Brunel Retail Park – Response to Highways Comments dated 20th April 2021 in relation to the proposed redevelopment of the Park

From: (e)Transport Development Control Floor 1 North Rear Civic Offices Bridge Street Reading RG1 2LU
To: Alison Amoah 0118 9372286 alison.amoah@reading.gov.uk
Date: 20 April 2021
Re: Consultation on Planning Application

Application Number: 201853

Address: Brunel Retail Park Rose Kiln Lane Reading

Drawing No. 19032_PL05 Rev. E

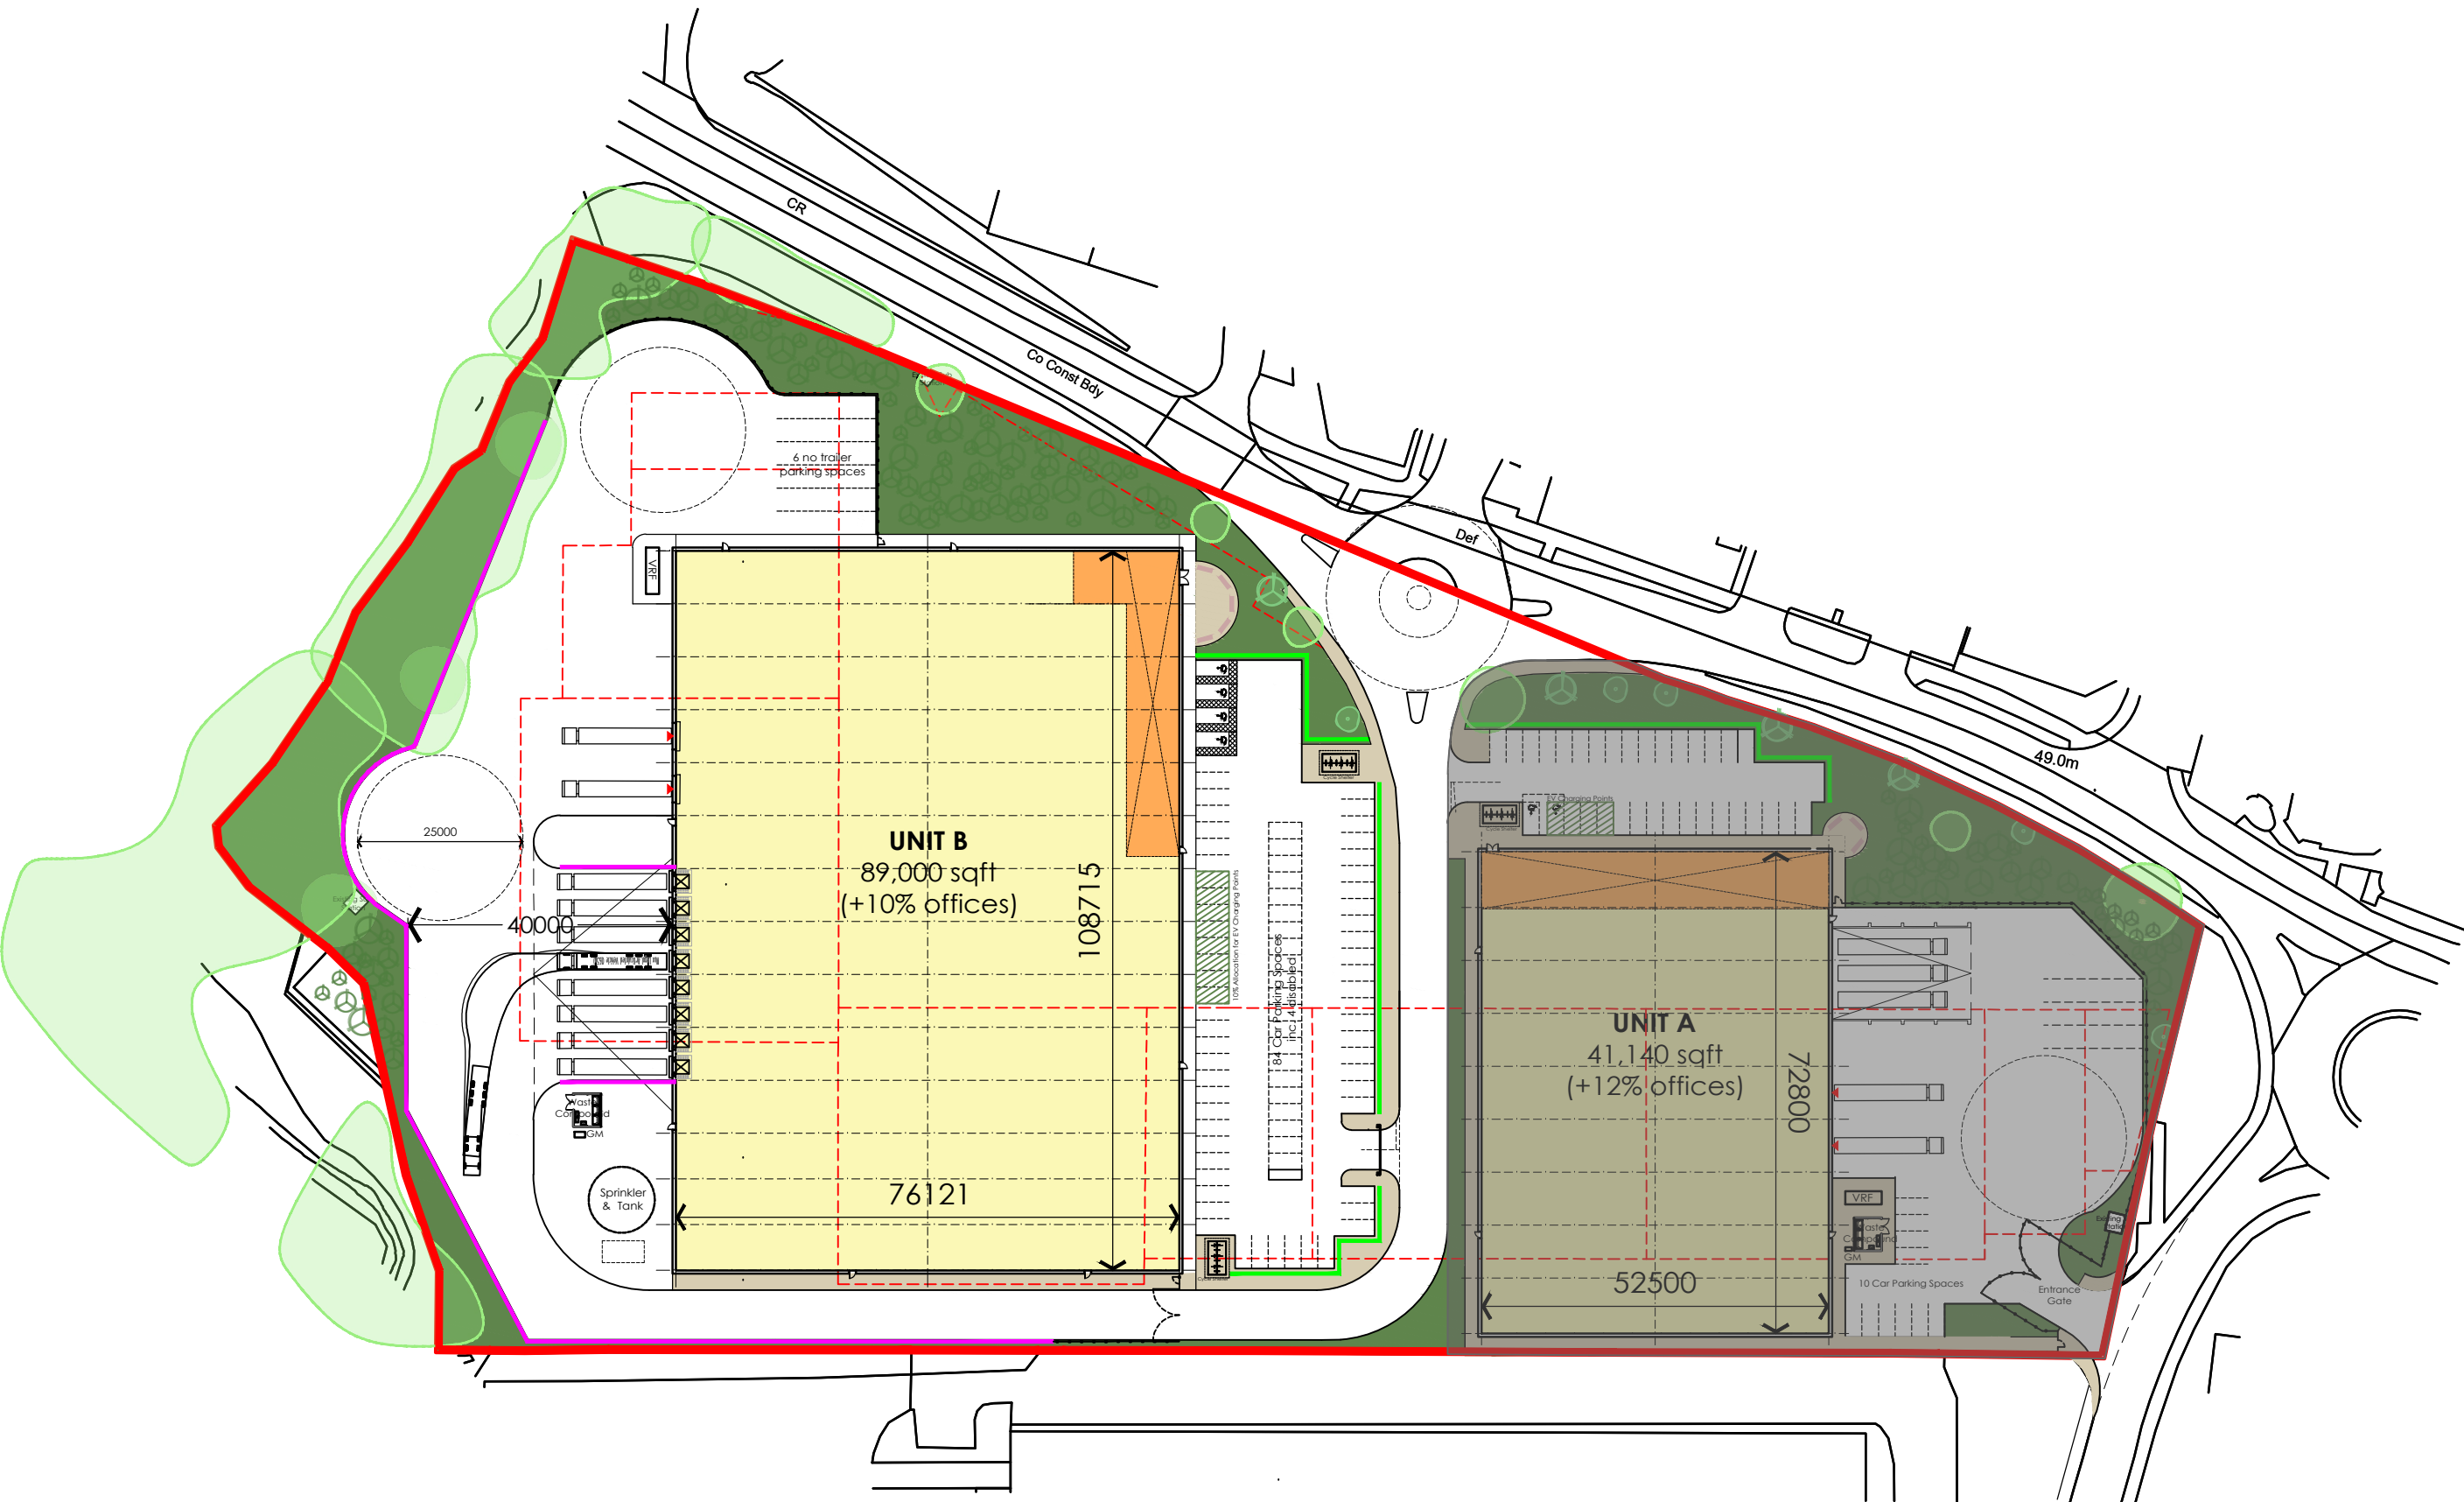
A footway is currently provided to the east of the site that leads to the side of the existing Costa coffee however this would no longer be required given that pedestrian access is being removed. The proposed scheme should therefore remove the footway and reinstate the grass verge.	The footway is neither within adopted highway or the control of the land lord, and as such the Applicant is not able to remove the footway.
Retail Parking: the proposals include 232 space in the customer car park and 65 spaces for staff in the service yard which equates to 1 space per 34sqm overall and 1 space per 44sqm for customers. It should be stated that these ratios are based on the floor areas that include mezzanines and is deemed acceptable. The provision includes 15 disabled spaces of which 12 are in the car park and 3 in the service yard. The overall provision is in accordance with standards and is deemed acceptable. However, the submitted drawings only illustrate the provision of 13 disabled bays and therefore a revised drawing is required increasing the proposed provision to meet the Councils standards.	A revised plan at Annex B illustrates a total of 13 disabled parking spaces

Commercial Parking: The proposals which include a mix of B Class uses with ancillary office space would be provided with parking for 43 cars including 33 in the car park and 10 in the service yard. This overall provision equates to 1 space per 95sqm GFA and in principle is deemed acceptable given the flexible use on the site. The provision includes 2 disabled spaces however, in line with the Councils Policy the provision of disabled bays should be a minimum of 3, a revised drawing should therefore be provided increasing the proposed disabled provision.	A revised plan at Annex B illustrates a total of 3 disabled parking spaces for the commercial element for Phase 1

However, the submitted drawings only illustrate the provision of 13 disabled bays and therefore a revised drawing is required increasing the proposed provision to meet the Councils standards.

The provision includes 2 disabled spaces however, in line with the Councils Policy the provision of disabled bays should be a minimum of 3, a revised drawing should therefore be provided increasing the proposed disabled provision.

Revision	A	Additional accessible and EV spaces added	29.04.2021	AE
----------	---	---	------------	----

Drawing Title
Visibility Splays

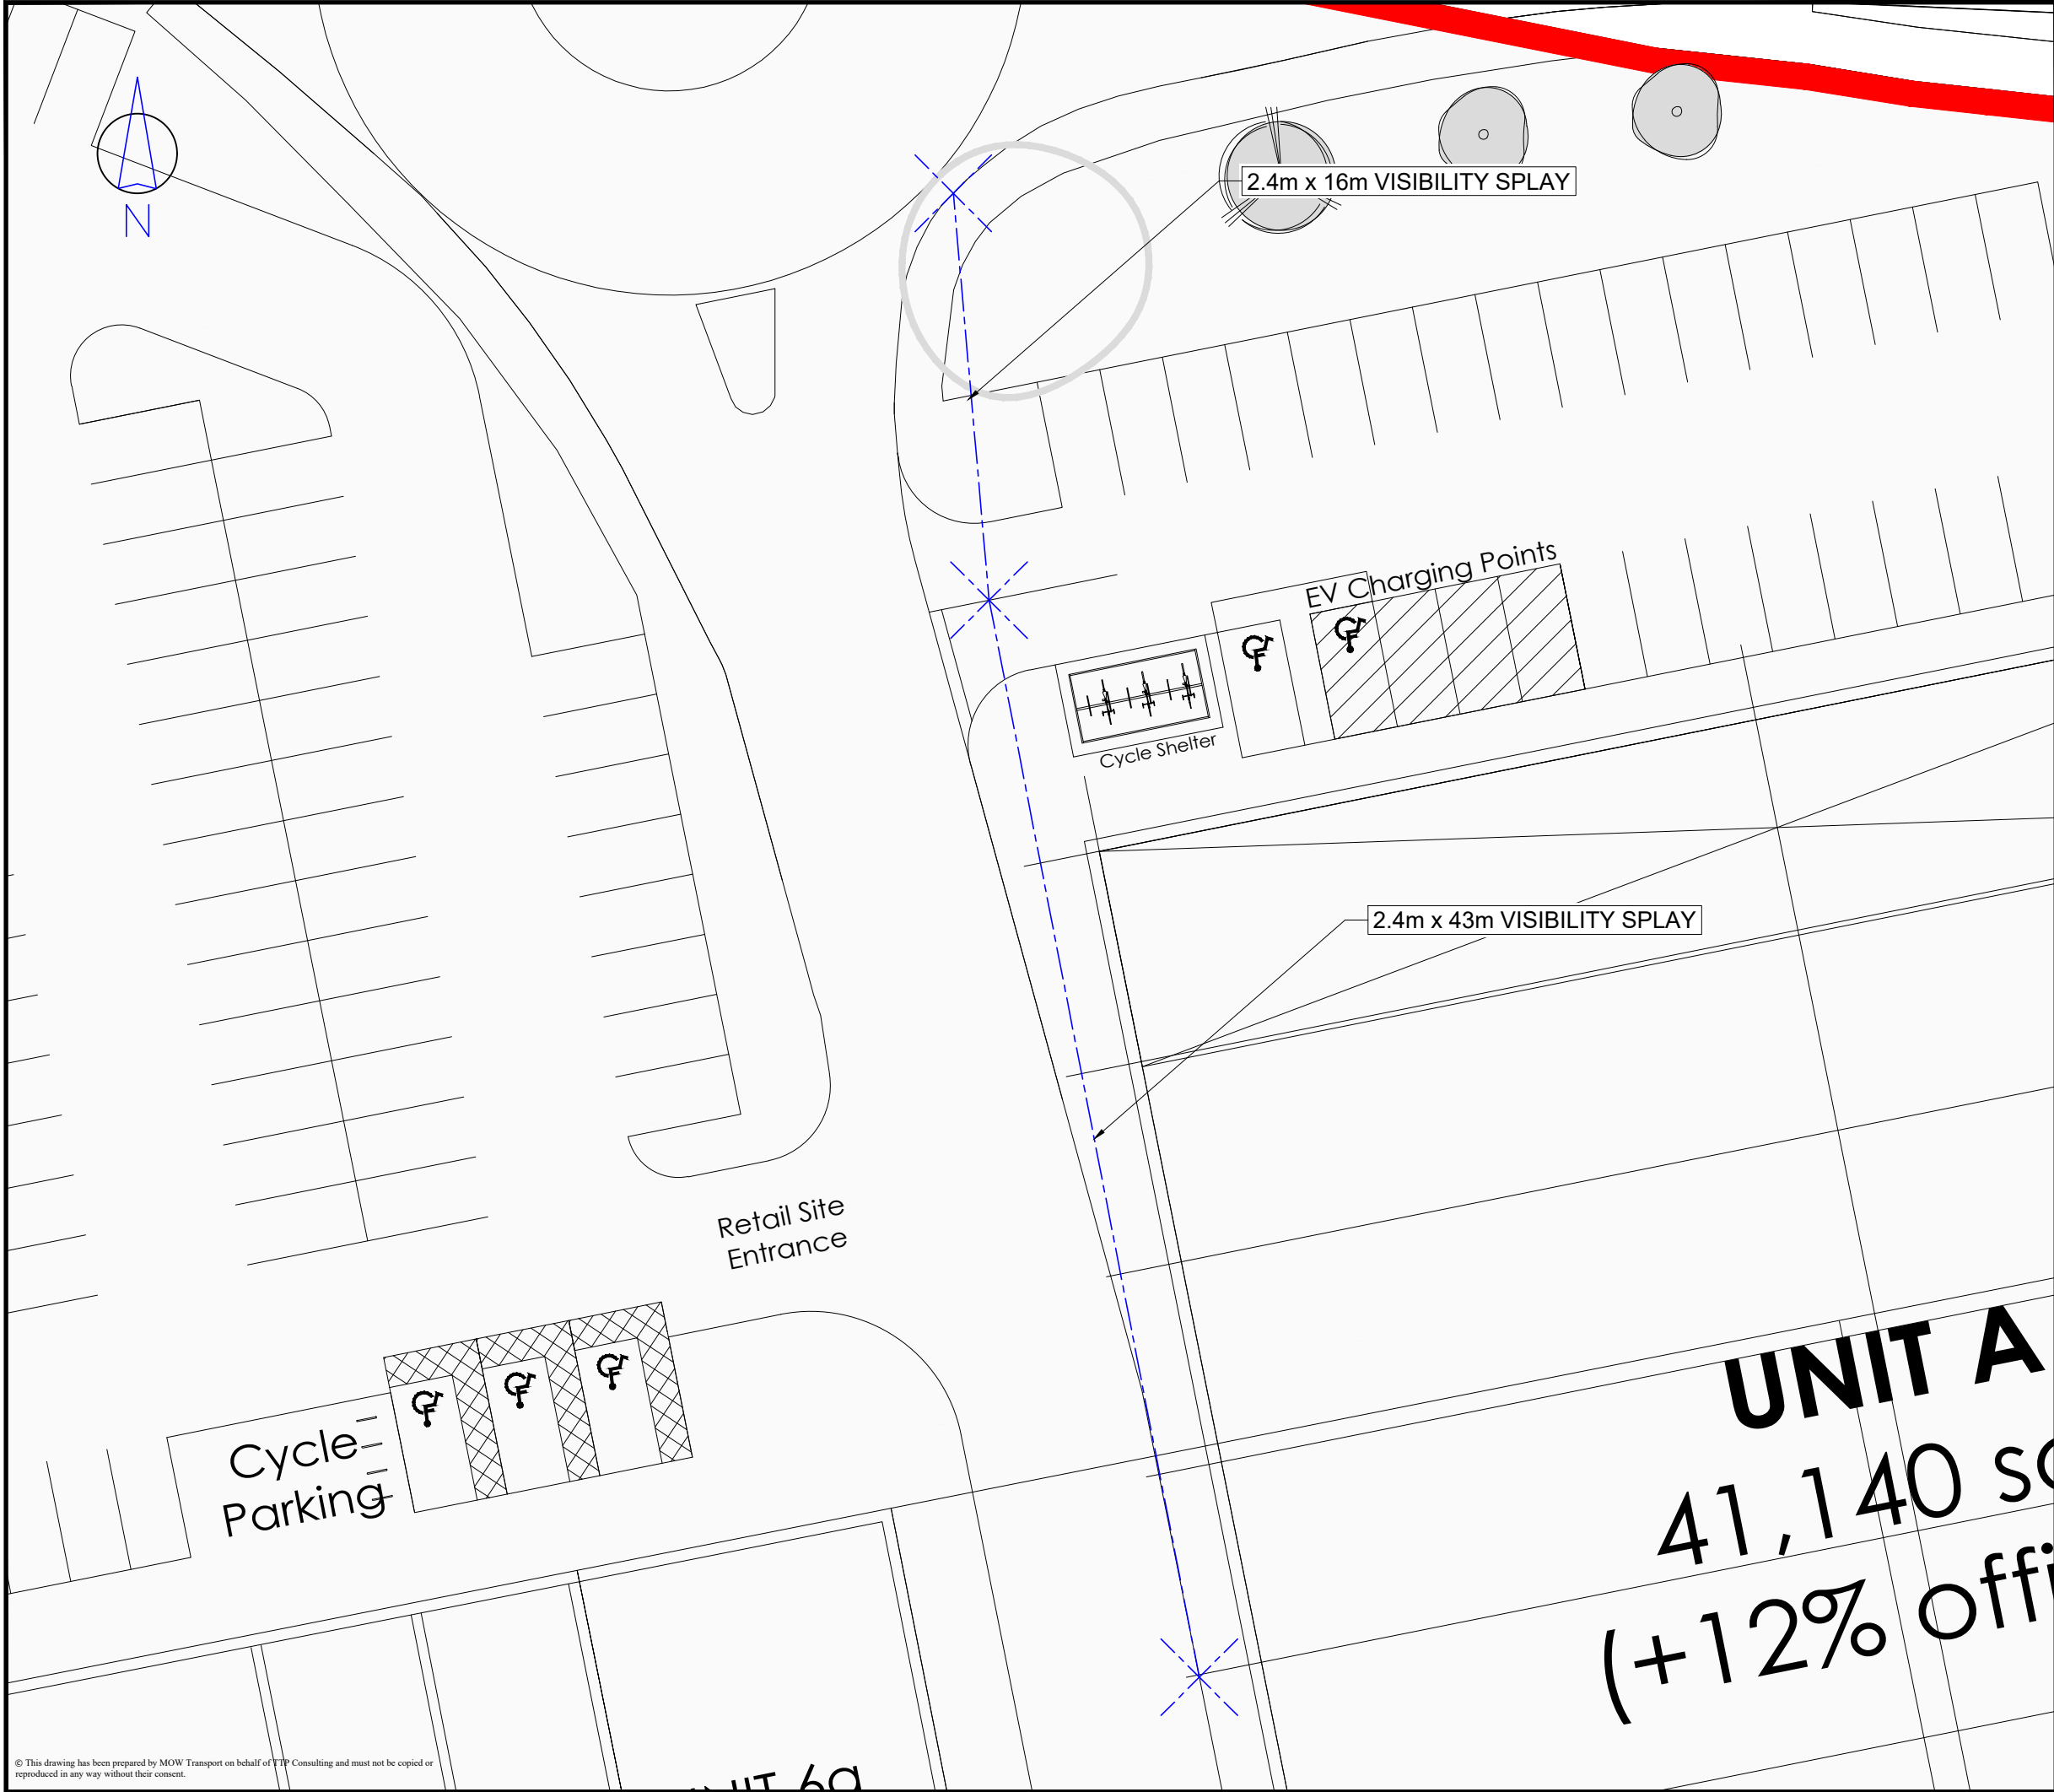
It should also be stated that the applicant has provided no visibility splays for this car park access and the submitted drawings indicate the provision of trees and cycle parking that would significantly impede any visibility for drivers exiting this car park.
